PLATTING BOARD AGENDA **ASSEMBLY CHAMBERS** **350 E DAHLIA AVENUE PALMER**

PLATTING BOARD MEETING **1:00 P.M.** **October 1, 2026**

STAFF REVIEW AND RECOMMENDATIONS
PUBLIC HEARING
OCTOBER 1, 2026

PRELIMINARY PLAT: KOPPENBERG ESTATES PHASE 2
LEGAL DESCRIPTION: SEC 7, T16N, R02W S.M., AK
PETITIONERS: AARON KOPPENBERG
SURVEYOR/ENGINEER: BULL MOOSE/ALASKA RIM
ACRES: 72.32 +/- PARCELS: 5
REVIEWED BY: CHRIS CURLIN CASE #: 2026-090

BULL MOOSE SURVEYING
200 E. MOOSE LANE OFFICE: 907.257.1234
BARTALA, ALASKA 99524 info@bullmoosesurveying.com
OWNER: THEO KOPPENBERG
DATE: 8/16/2025
CHECKED BY: RWH
SCALE: 1" = 200'
SHEET: 1 OF 1

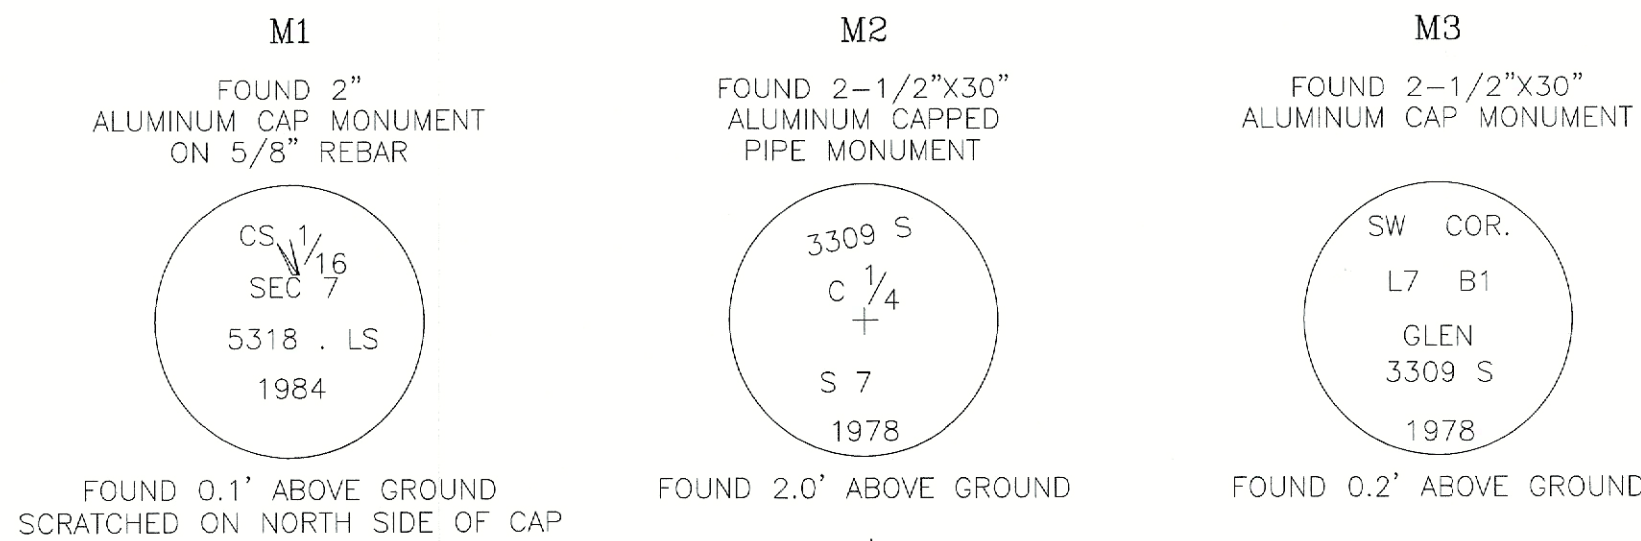
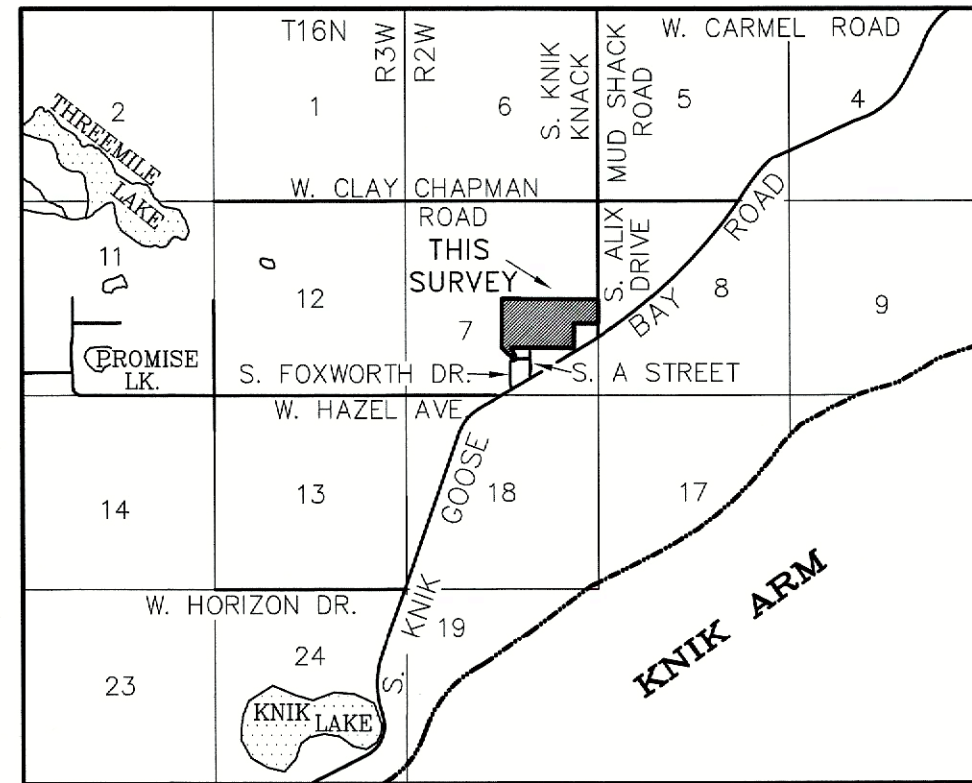
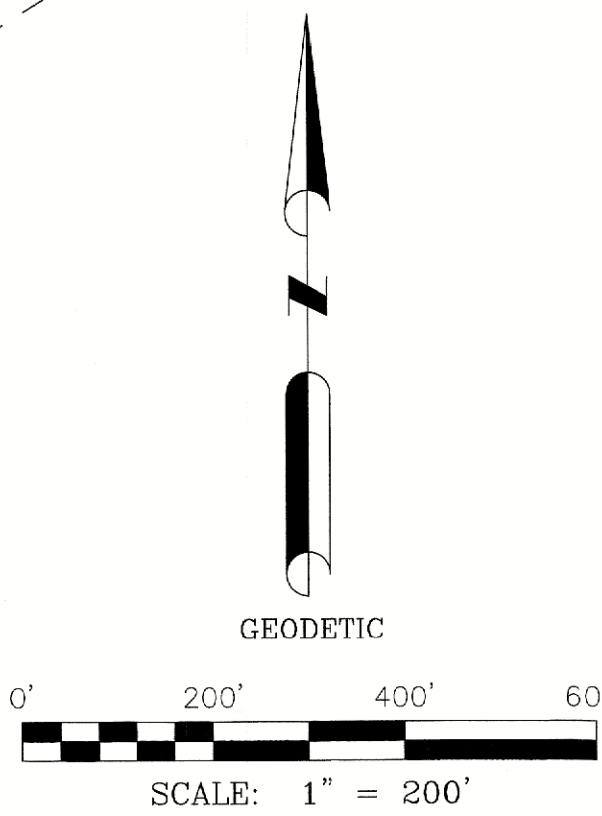
DPW Pre-Design and Engineering: (**Exhibit C**) The proposed cul de sac/extension of A Street shall be constructed to a minimum of residential standards in accordance with the 2022 Subdivision Construction Manual. Removal of the existing cul de sac at the end of A Street shall be coordinated with DPW to occur at the end of the warranty period of the road improvements.

3. Pay postage and advertising fees.
4. Construct cul-de-sac to residential street standards according to the 2022 Subdivision Construction Manual (SCM):

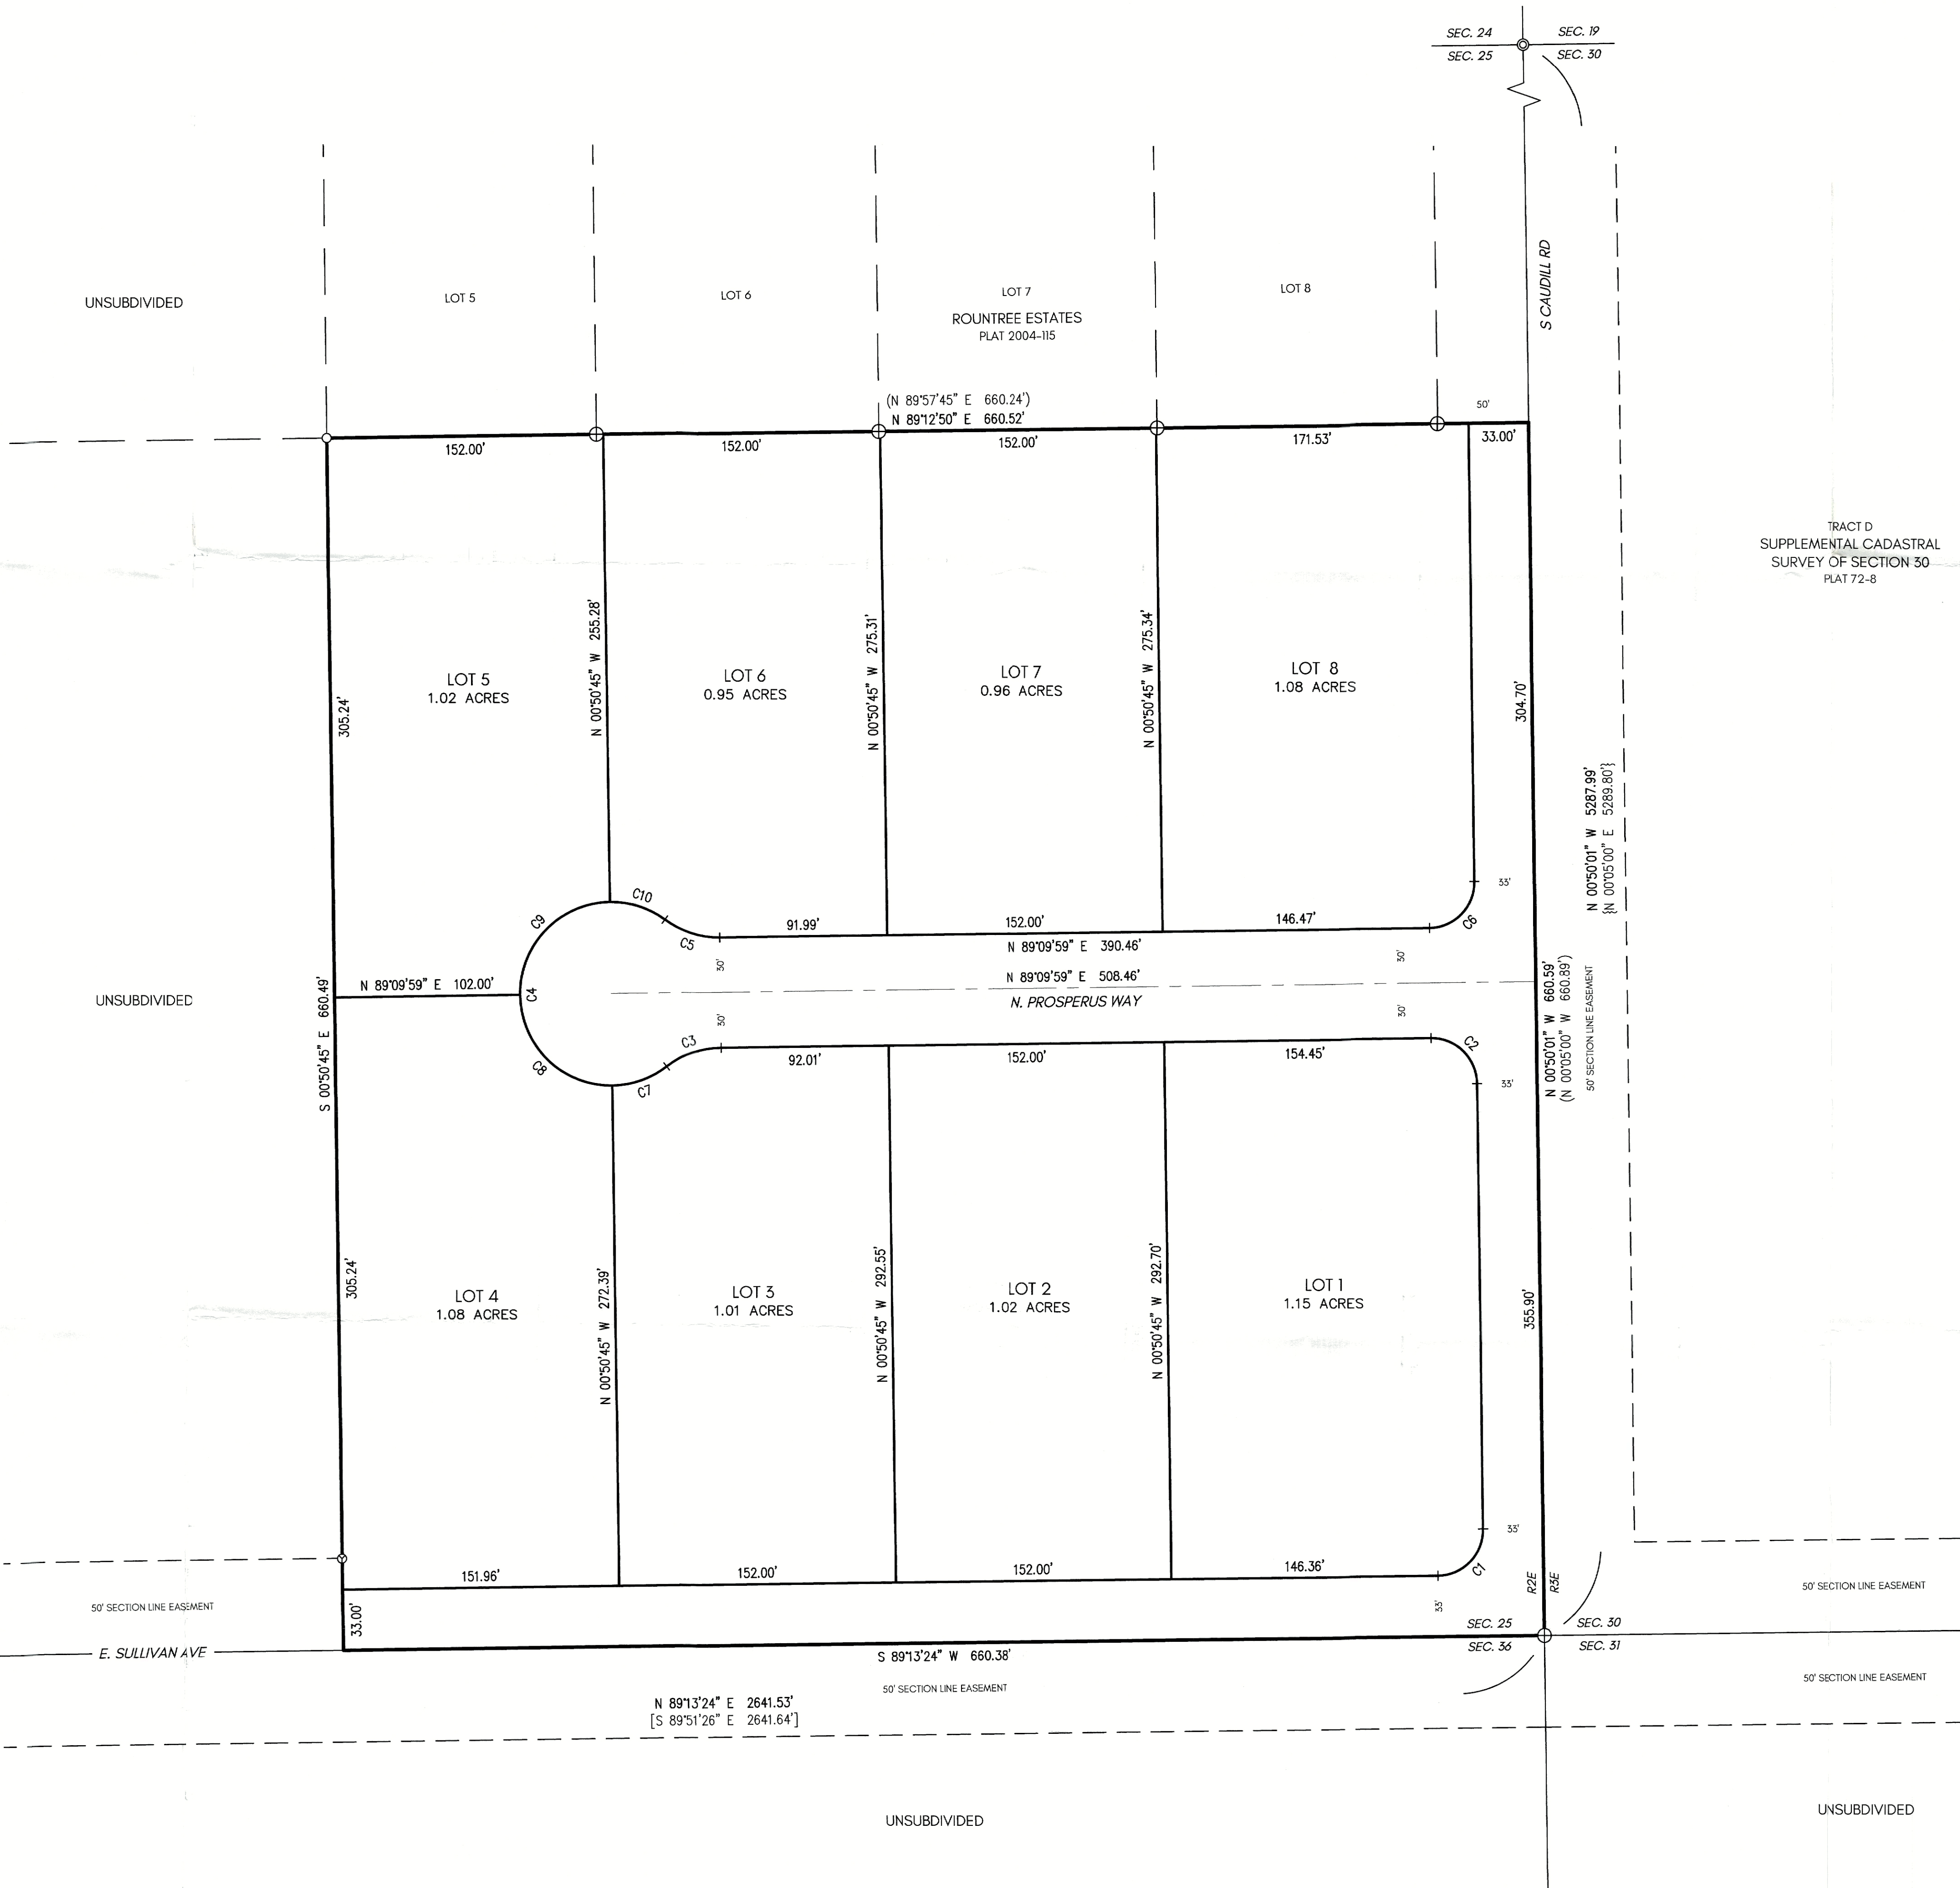
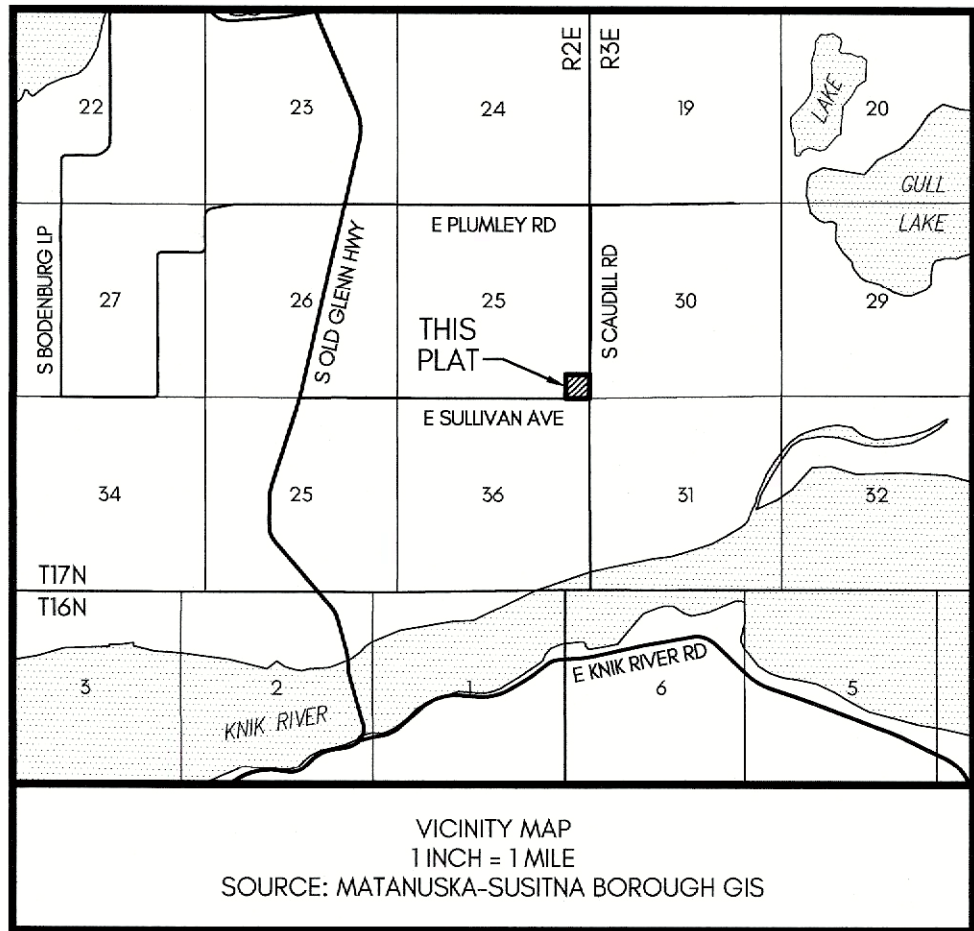
Please provide a legible test hole location map. The fence and any other encroachments located in the dedicated right of way shall be removed.

5. Grant a 15' utility easement along both sides of Prosperous Circle and around the culdesac.
6. Remove any encroachments located in the dedicated right of way.
